**CERTIFICATE OF APPROPRIATENESS**

**Property:** 4102 Watson Street, lot 4, block 206, East Norhill Subdivision. The property includes a historic 1,316 square foot, one-story wood frame single-family residence and an 841 square foot detached two-story garage situated on a 6,240 square foot (52' x 120') corner lot.

**Proposal:** Alteration – Construct a 1,100 square foot two-story addition to the 1,316 square foot contributing residence.

**Recommendation: Approval**  
**HAHC Action: Approved**

WEST ELEVATION – FRONT FACING WATSON

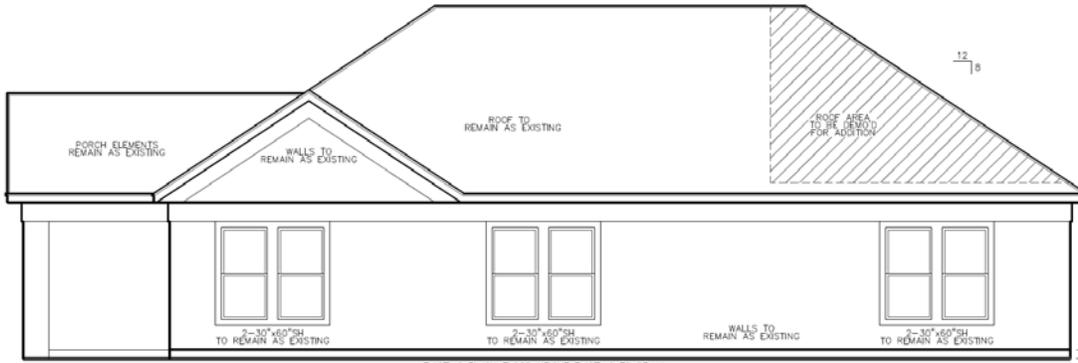
**Front Elevation:** The front elevation of the existing house will not be altered. The addition will be built over the rear 16' of the house starting 32'-10" from the front wall (previously proposed at 23'-7"). The addition will feature a hipped roof with a front facing gable sided with shake shingles.

**SOUTH SIDE ELEVATION – SIDE FACING MELWOOD**

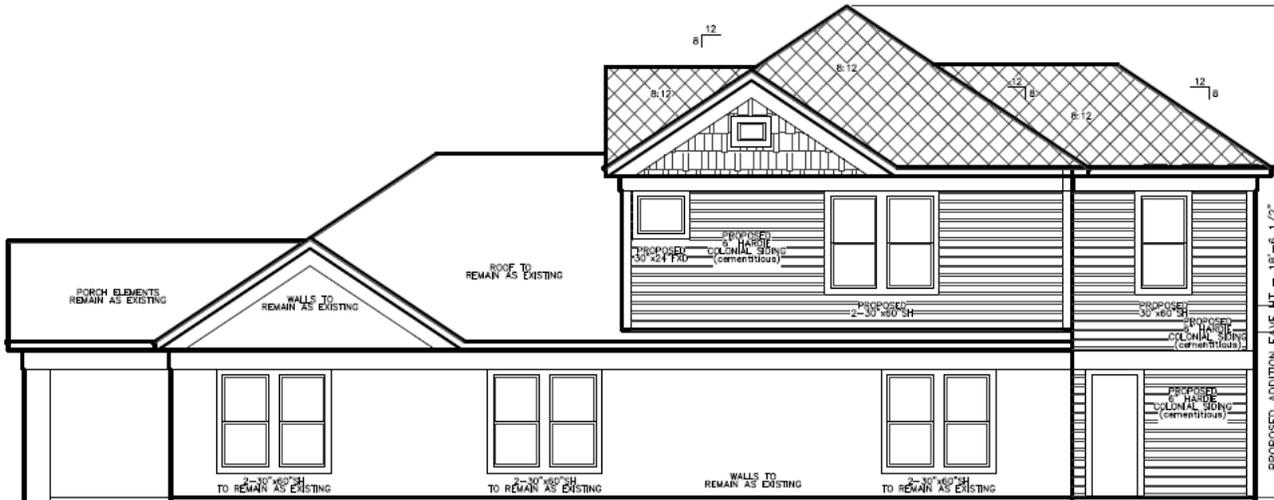
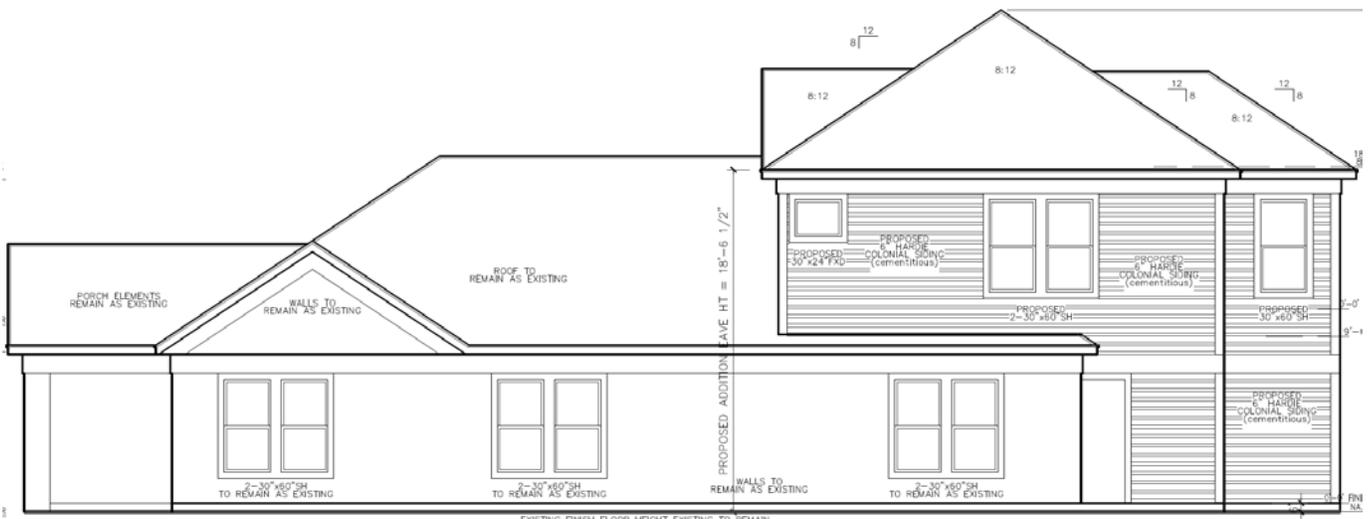
**Side Elevation:** Other than the area of roof to be removed to accommodate the addition, no other components of the south elevation of the existing house will be altered. The addition features a fixed window and a pair of double hung windows at the second level at the wall closest to W Melwood St. The south facing wall of the setback portion of the addition will feature a single double hung window at the second level.

**NORTH SIDE ELEVATION**

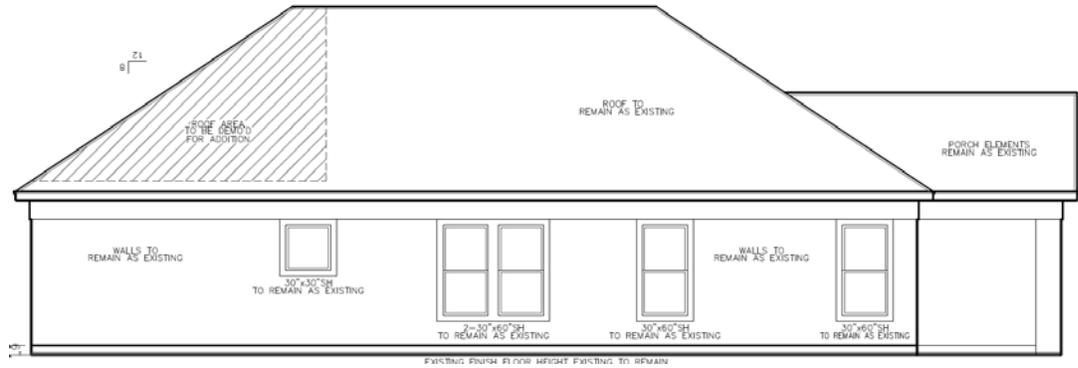
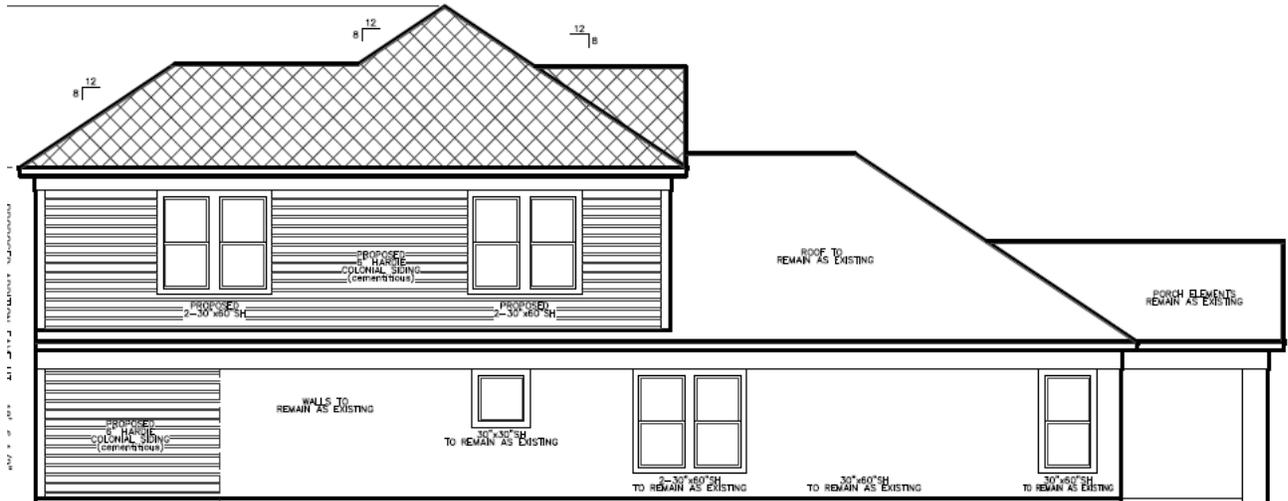
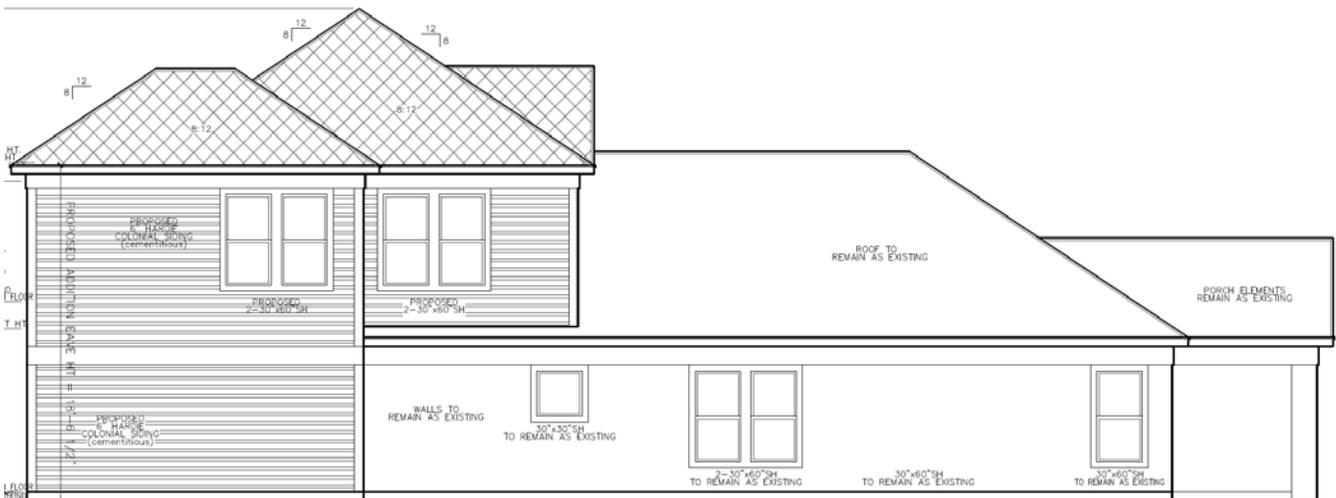
**Side Elevation:** Approximately 1' of the rear north wall and a portion of the roof will be removed to accommodate the addition. No other components of the north elevation of the existing house will be altered.

**EAST (REAR) ELEVATION**

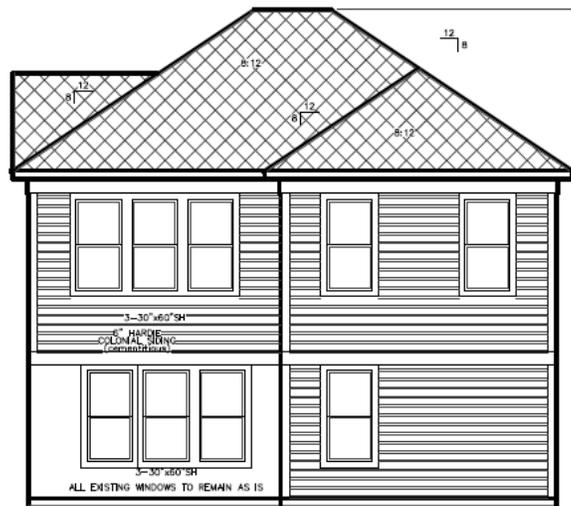
**Rear Elevation:** The addition will extend towards the rear property line at the second level. At the first level will be an open covered patio. Approximately half of the original rear wall closest to W Melwood will remain, featuring the original brick siding and set of three double hung windows. The portion of the addition above the porch will feature a set of three double hung windows at the second level. The northwest corner portion of the addition will feature a single double hung window at the first level and two double hung windows at the second level.

SITE PLAN

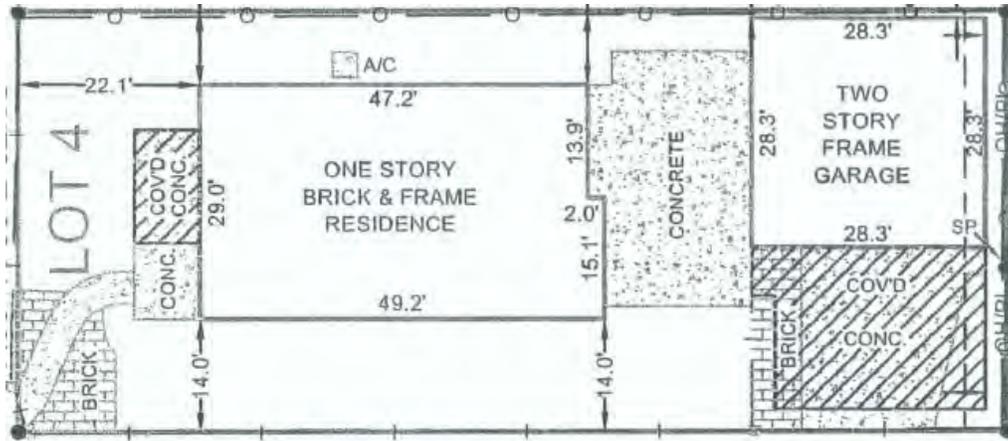
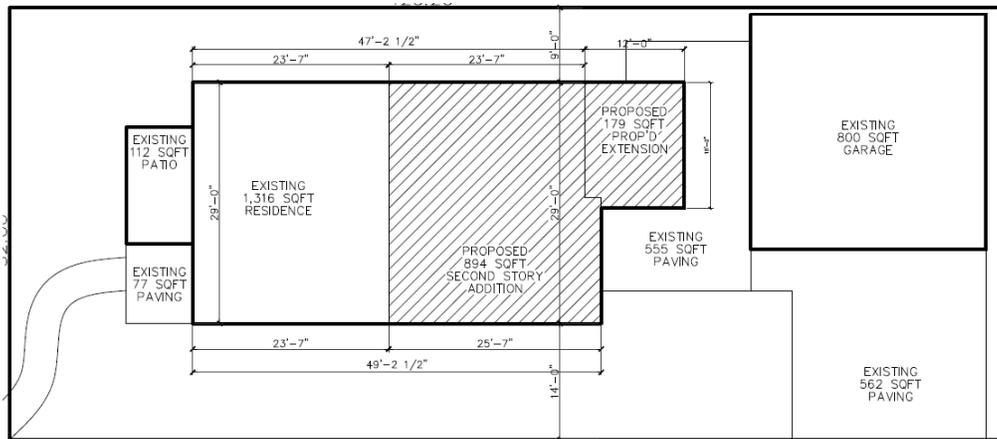
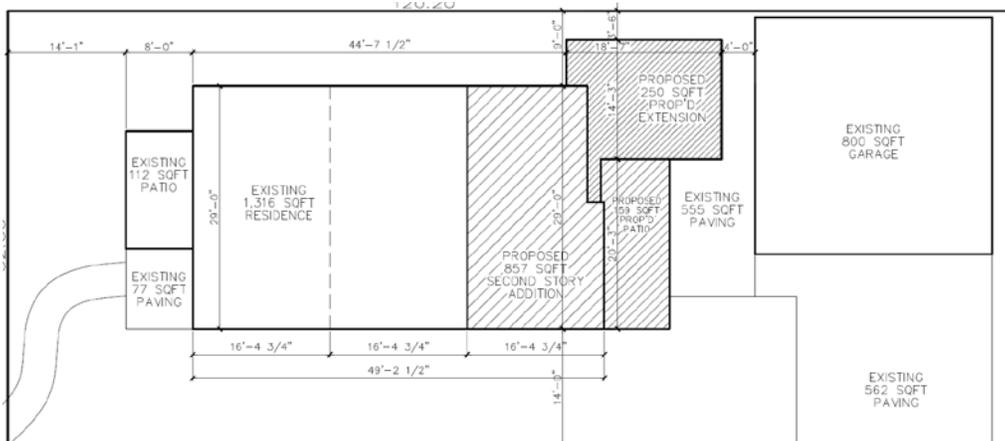
**Setbacks:** The existing house is situated on the northeast corner of Watson Street and W Melwood Street. It features a setback of 14' along Watson Street (west), a 14' setback along W Melwood Street (south) and a 9' setback along the northern property line. The addition will maintain the W Melwood St. setback, and will have a 3'-6" setback on the interior north side property line.

**ROOF PLAN  
EXISTING**

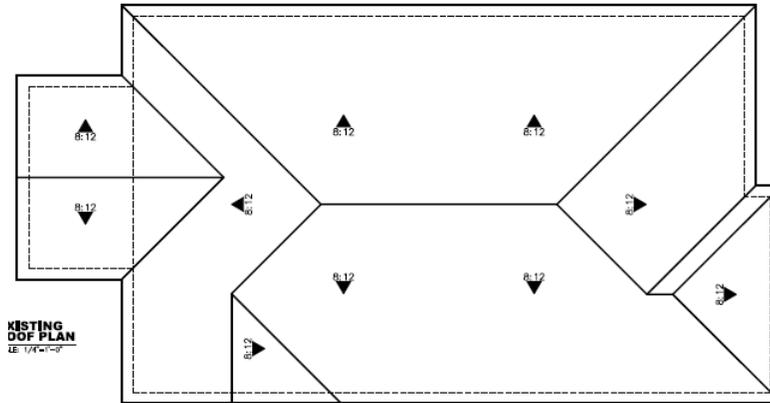
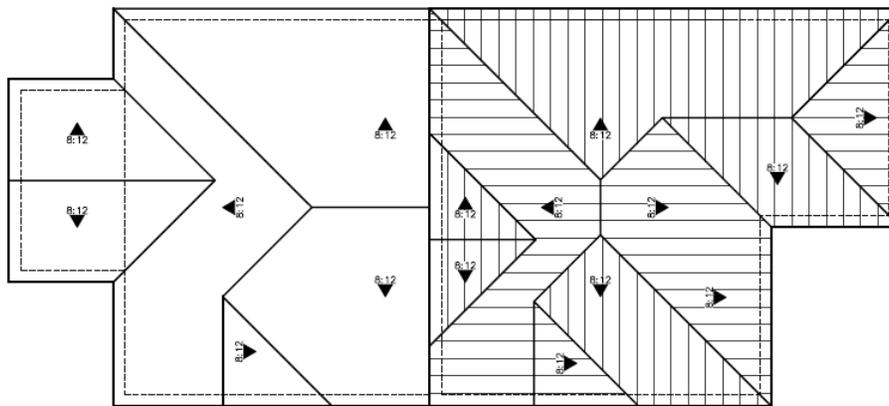
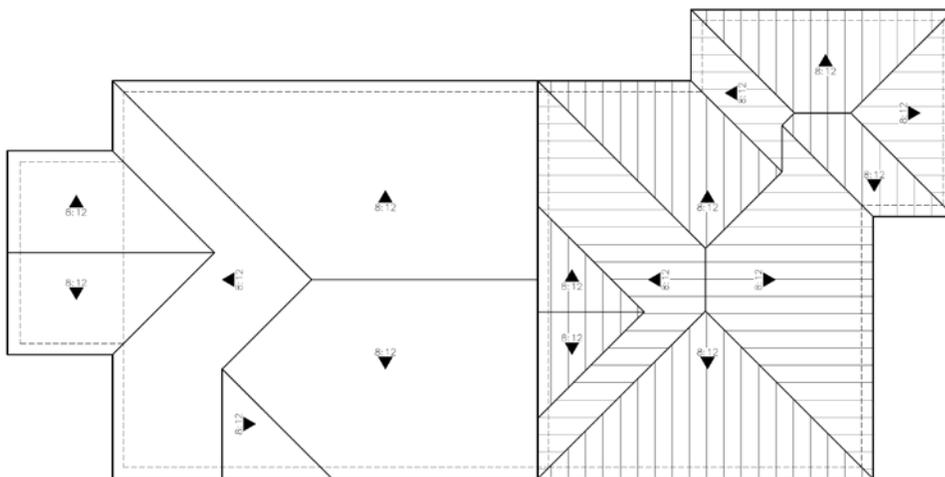
**Roof:** The existing home features an 8/12 pitch hipped roof with a front facing gable over the porch and a south side facing gable at the front of the house. The addition will feature a hipped roof with an 8/12 pitch and a small front facing gable. The new gables will feature wood shingle siding matching the existing gables.

FIRST & SECOND LEVEL FLOOR PLANS

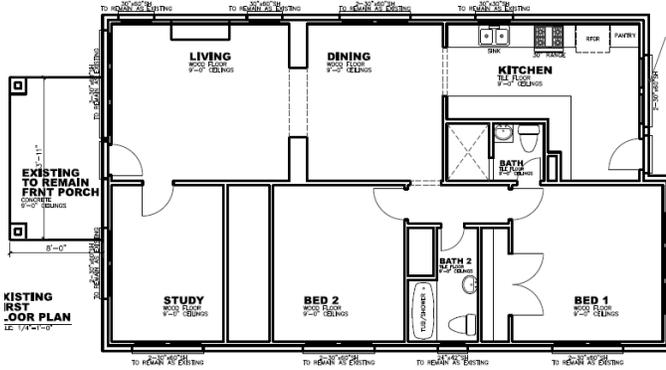
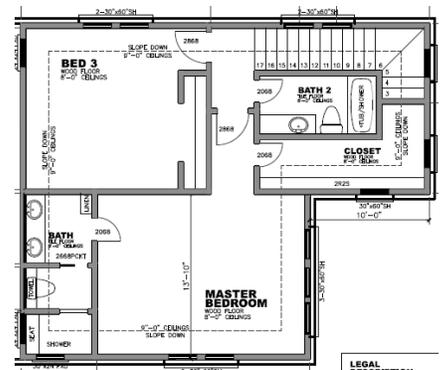
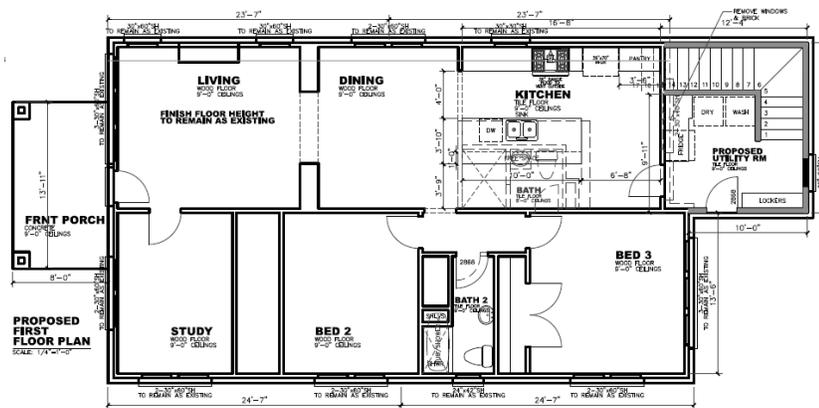
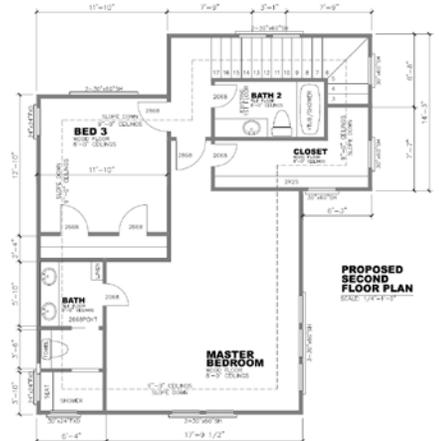
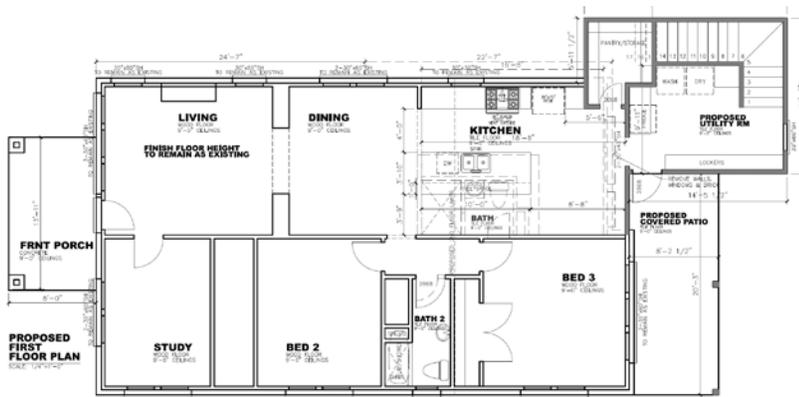
**Shape/Mass:** The existing house measures 29' wide by 49' deep and features an eave height of 9' and a ridge height of 19'. The second story addition will be built on top of the rear 16'-5" of the existing structure (previously proposed over 25'-7"). An 18'-7" deep by 14'-3" wide portion of the addition located in the northeast corner of the structure will extend 6' out from the existing structure towards the north interior property line. The portion of the addition closest to W Melwood will extend 8' behind the rear wall at the second level; below will be an open covered patio. The addition will feature an eave height of 19' and a ridge height of 28'.
